FLIGHT READINESS STATEMENT
STS-86/ET-88
EXTERNAL TANK PROJECT
PRE-FLIGHT REVIEW

Space Shuttle
External Tank

STS-86/ET-88
Pre-Flight Review

Composite Nose Cone Implementation

Composite Nose Cone Implementation

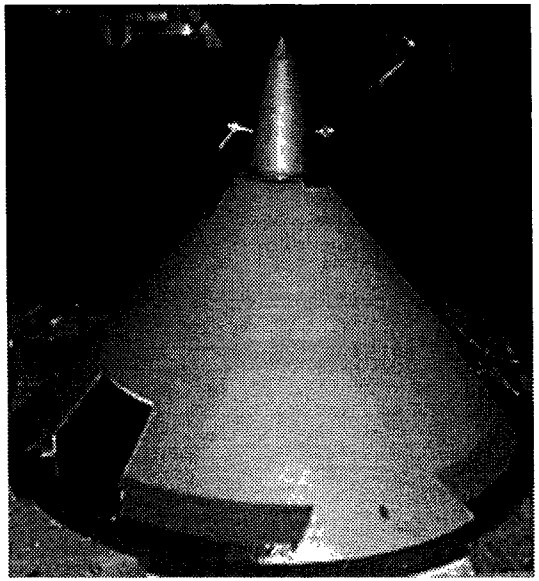
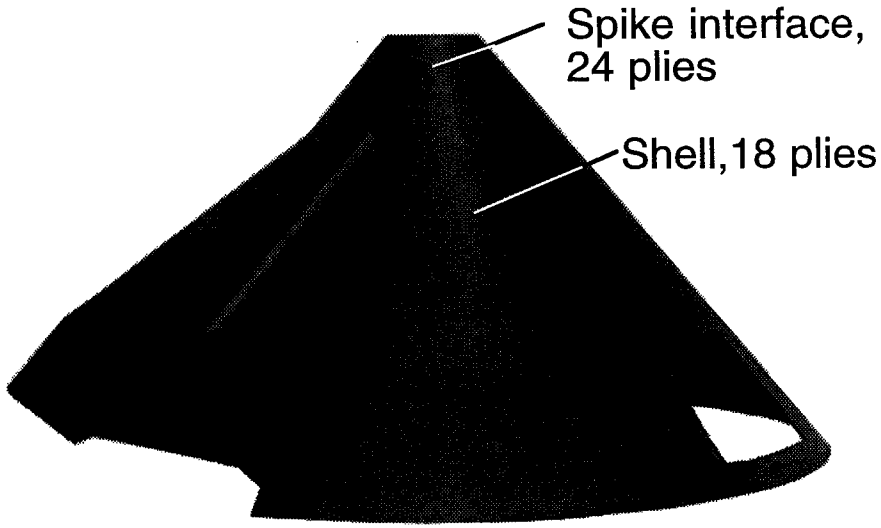
- Implementation of composite nose cone

- Program established for development and verification of composite structures for ET application
  - Emphasis on enhanced reliability/performance
    - TPS debris potential eliminated
- Early incorporation of change on ET-88 diminishes number of first time configuration changes for SLWT

Material	• Al 2024 skin/fairing/frames • Al 6061 mounting frame • SLA-561S, SLA-561M	• Graphite/Phenolic shell • Ti-6-4V attachment brackets
Parts	81	29
Fasteners	1117	56
Weight	116.2 lbs	105.2 lbs

- Stress: Meets required FS (1.40)
    - Was: Metal nose cone = 2.07
    - Now: Composite nose cone = 1.68 (failure mode: direct strain)
  - Thermal: Temperatures within mechanical property and ablation test data base

Alternate Blowing Agent Foam Implementation

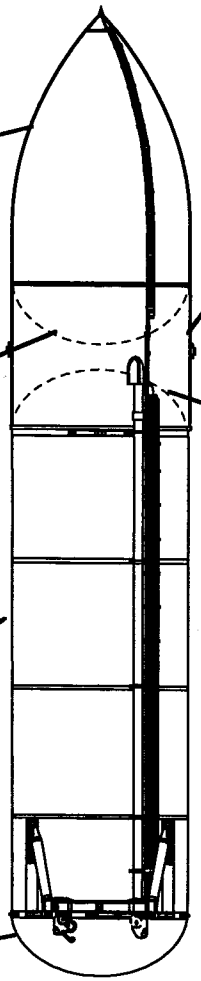
Implement use of alternate blowing agent foams
- NCFI 24-124 on Intertank sidewall

STS-86 (ET-88) and subs
- **NCFI 24-124 on Intertank sidewall**
